# M25 junction 28 improvement scheme

TR010029

## 8.1 Statement of Common Ground with Environment Agency

<b>Regulation Number:</b>	Regulation 5(2)(q)
<b>Planning Inspectorate Scheme Reference:</b>	TR010029
<b>Application Document Reference:</b>	TR010029/APP/8.1
<b>Author:</b>	M25 junction 28 improvement scheme project team, Highways England

Figure 1 – location of components affecting water environment

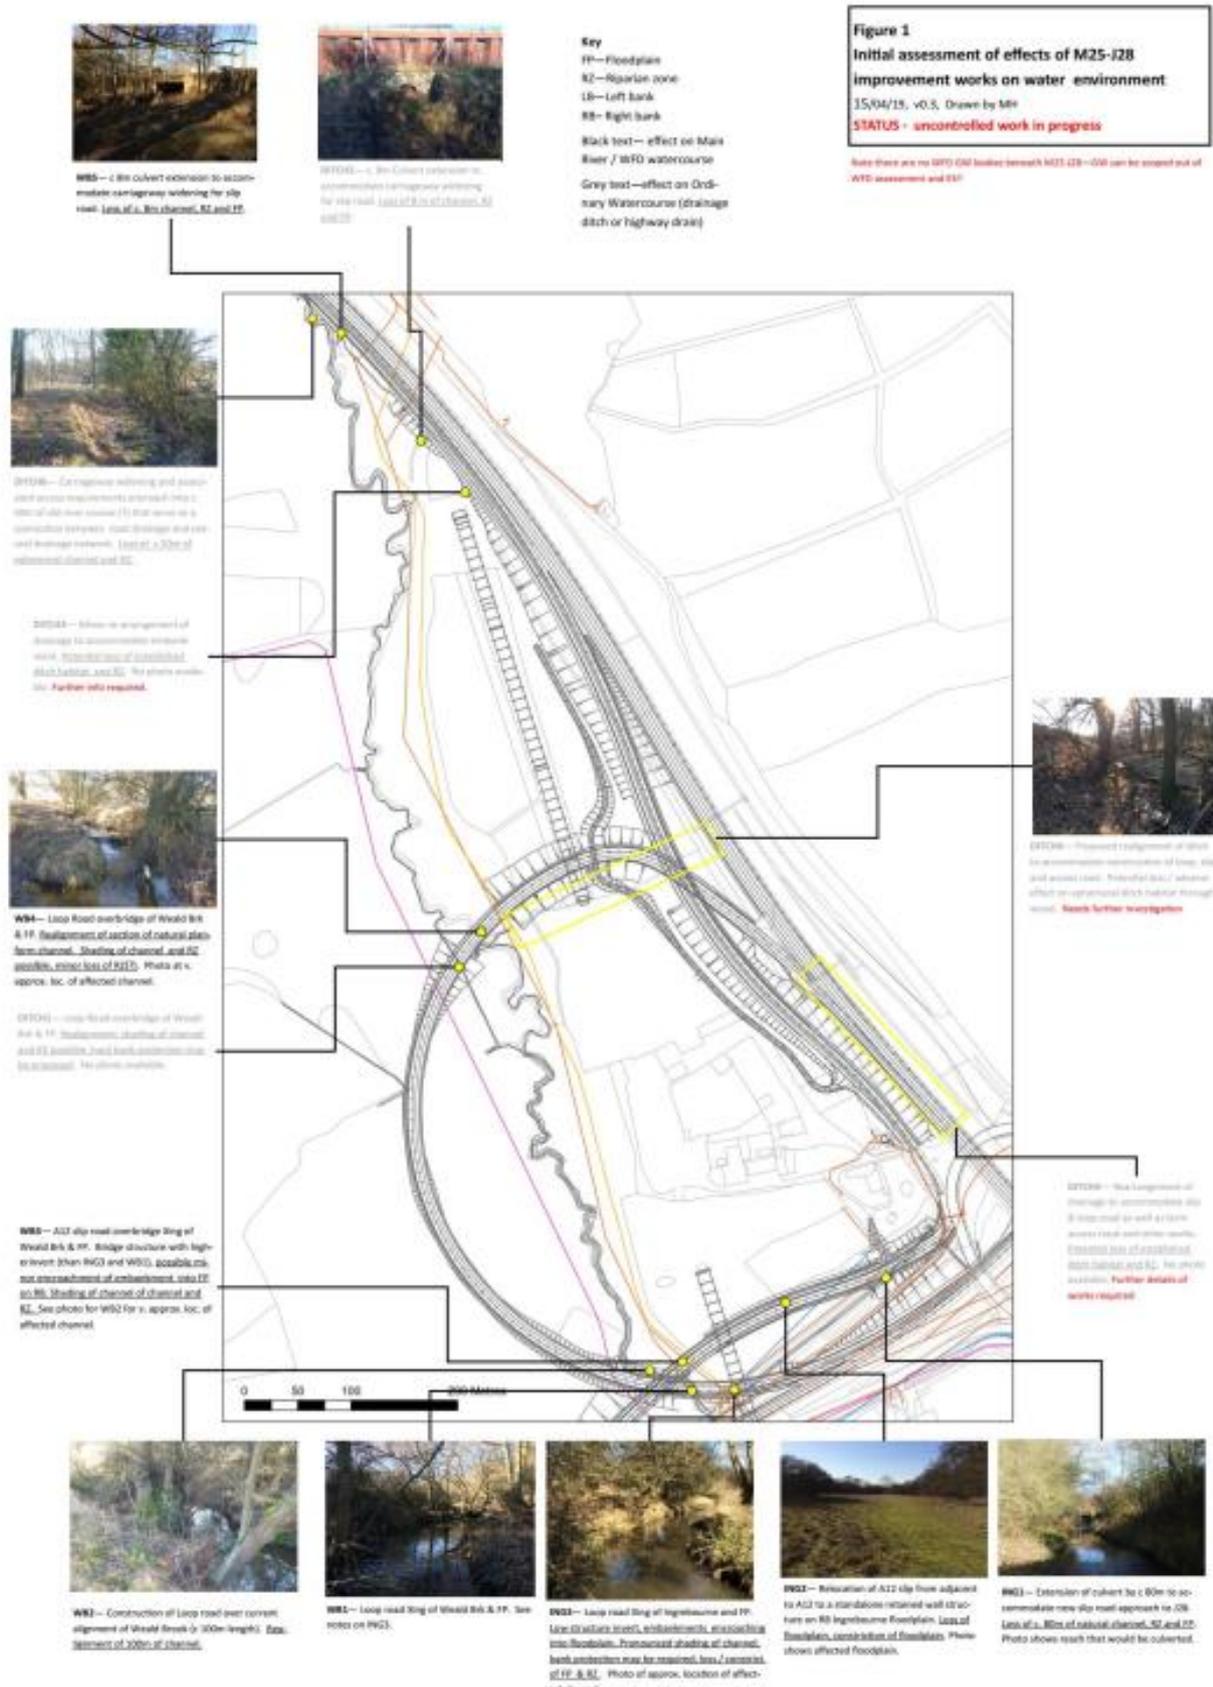
Scheme component (see fig. 1)	Name	Discussion points
	Brook and FP	<ul style="list-style-type: none"> <li>o EA asked if Atkins can investigate retaining the upstream two meanders in the proposed realignment (Action [redacted] – look into this design change)</li> <li>o EA generally happy with proposed mitigation – restoration of a similar length of existing straightened channel to more natural form</li> </ul>
WB5	Culvert extension on M25 Weald Brook Xing	<ul style="list-style-type: none"> <li>o Discussed briefly. Principles set out in "Initial thoughts from EA" for ING1 apply (though obviously at a much smaller scale, given the 8m extension here). (Action [redacted] – update mitigation, given that existing proposals are not adequate – can probably be included into proposed restoration elsewhere on Weald Brook)</li> </ul>
Ditches		Not discussed at meeting (of lesser significance than effects on main river)

MIT4a,b,c	Within the restrictions defined by other constraints (most notably services, road safety and cost) structures have been set as high and wide as feasible.						Y	Y								
COMP1	Realignment of Ingrebooms, creation of backwaters, reconnection of floodplain.	Y	Y	Y	Y											Base width of channel is taken as 1m. Bankfull width taken as 9m. Channel is typically 1.5m deep
COMP2a,b,c	Ground lowering to increase floodplain storage.		Y	Y	Y											
COMP3	Riparian zone tree works to create varied light intensity, either by selected tree removal / coping or tree planting, depending on conditions.			Y	Y		Y	Y	Y							Strategic tree felling / planting to vary intensity of light reaching river and riparian zone. Different light intensities encourage different habitats.
COMP4a-e	Floodplain wetting by retaining natural surface water drainage on floodplain, or lowering floodplain.			Y	Y				Y							Wetter floodplain created by a) reducing the rate (or preventing) water draining to the river or b) scrapes to lower floodplain. Limited earth movement anticipated.

COMP5	Channel realigned with natural cross section. Additional realignment / restoration of planform of modified channel further upstream.					Y		Y								
COMP6	Realignment of c. 40m of drainage ditch into naturalised channel with scrapes.									Y						
COMP7	Restoration of planform of modified channel further downstream. Backwaters at Crossing.							Y								
COMP8	Floodplain scrape to create wetland area.										Y					
COMP9	New backwater created, returning to river 20 m downstream.														Y	
COMP10	Floodplain scrape to create wetland area.							Y								
COMP11	Floodplain scrape to create wetland area.									Y						
COMP?													?	?

Figure 1 Ingrebourne River (French's Farm)

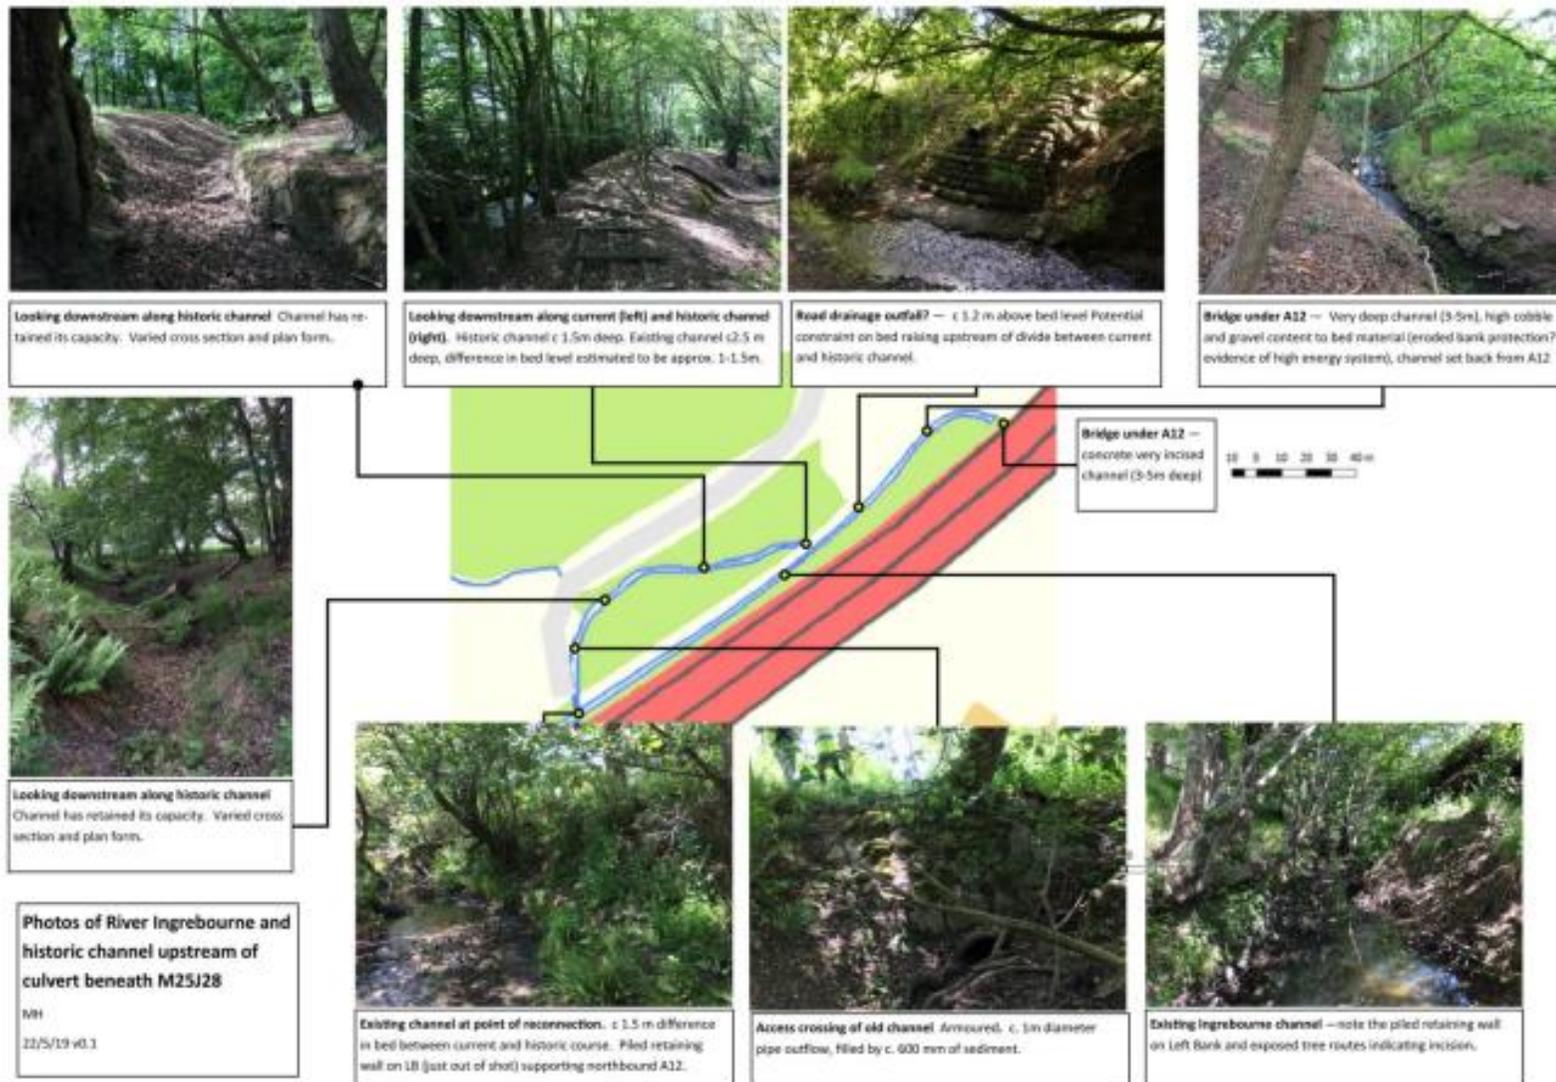
Natural geomorphological process has re-established limited sinuosity and complexity in channel cross sectional and long sectional form. For instance, along reaches with trees, incision has exposed roots and boughs of trees, creating habitat complexity. Where incision has been into mineral material, complexity has been created by deposition of side bars and runs with a substantial gravel content (see photos in Figure 1).

For this reason, the consensus during the site visit was that there was minimal ecological benefit to installing in channel restoration features along this reach of the Ingrebourne. Restoration features will achieve little more that is already developing naturally, given the substantial constraints of the deep and steep channel.

Figure 3 Action straw doll conceptual design schematic

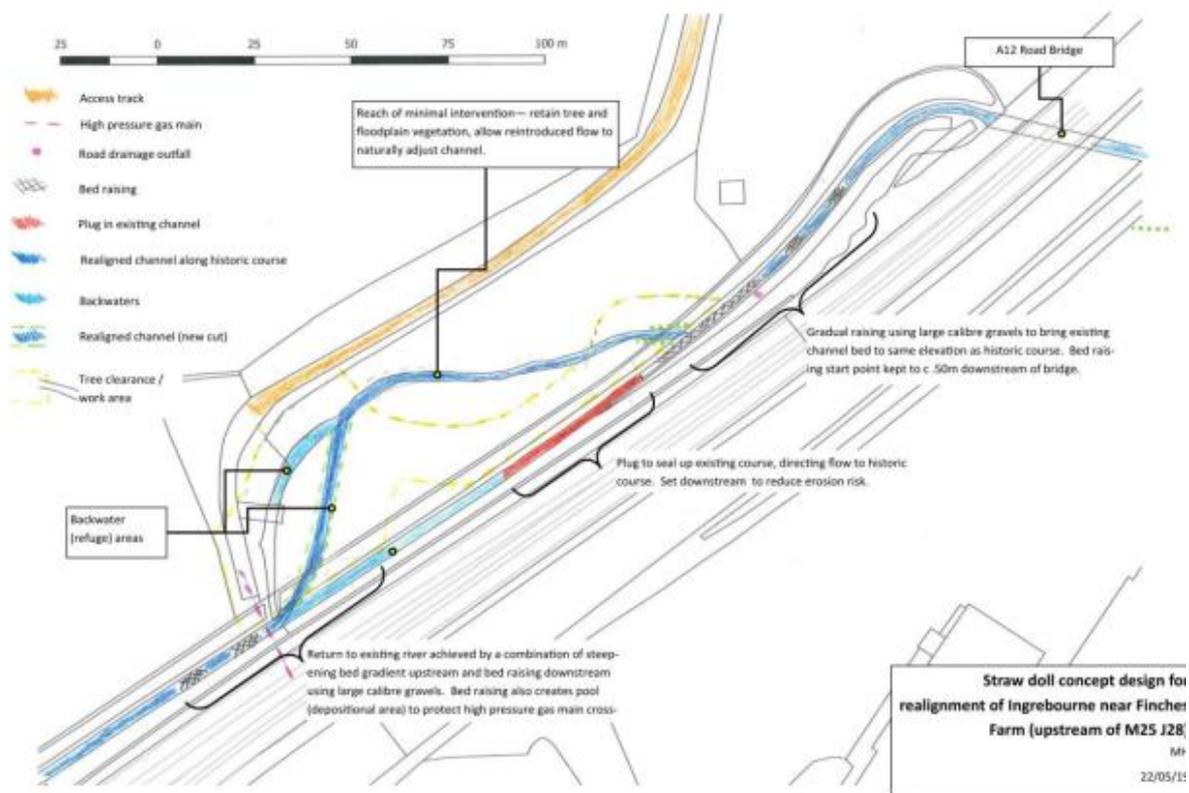
A conceptual design based on discussions during the field visit presented in Figure 3. This is intended as a starting point and a trigger for discussion on determining feasibility of this intervention

Figure 3 Action straw doll conceptual design schematic

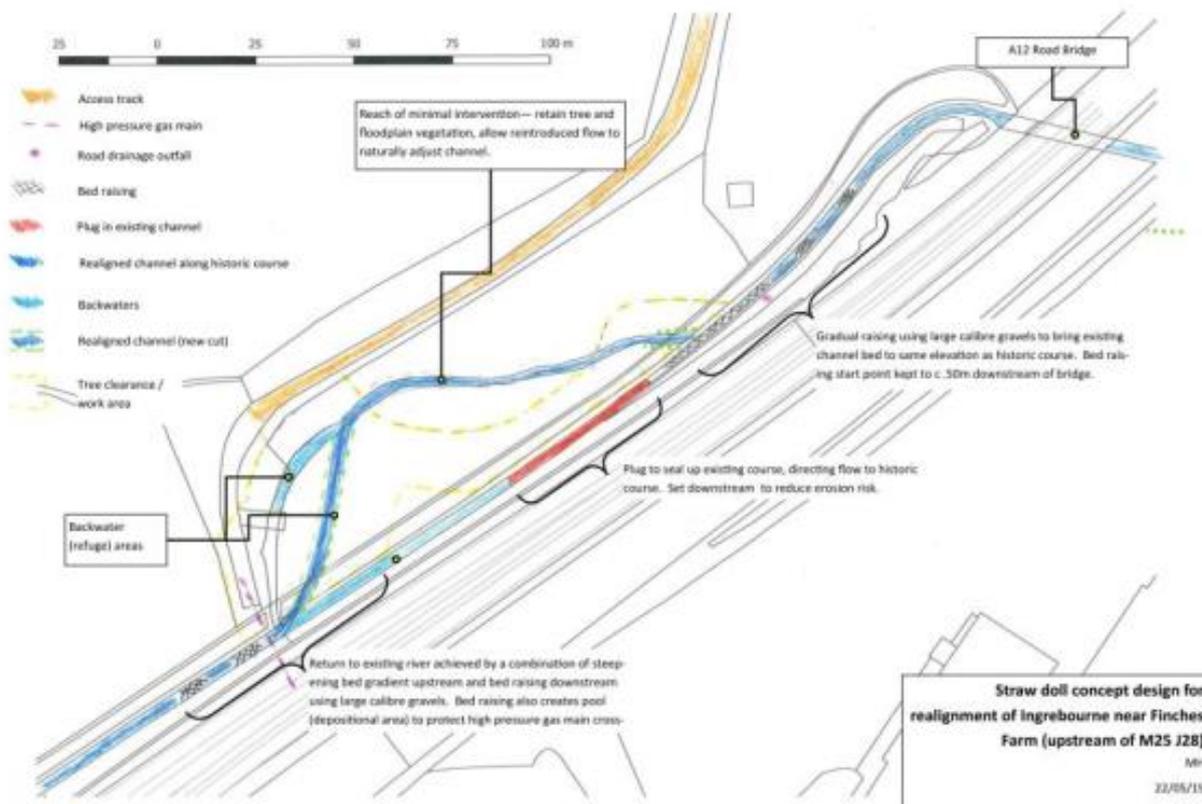
- [redacted] advised that there is benefits to proceeding with the additional mitigation on the upstream section.
- [redacted] advised that during the site visit when we were walking the main Scheme, we identified a dry ditch running along north section of the Scheme. [redacted] advised that there is going to be a lot of unlined ditches provided for the Scheme so the Scheme will be creating far more ditch then it takes out. [redacted] advised that these ditches provide both terrestrial and aquatic habitat – and part of this habitat is the interaction of ditches and trees. He queried how these new ditches would replicate the current ditches. [redacted] advised that the drainage design isn't so detailed at the stage but we can include commitments to looking into the ditch design in the REAC.
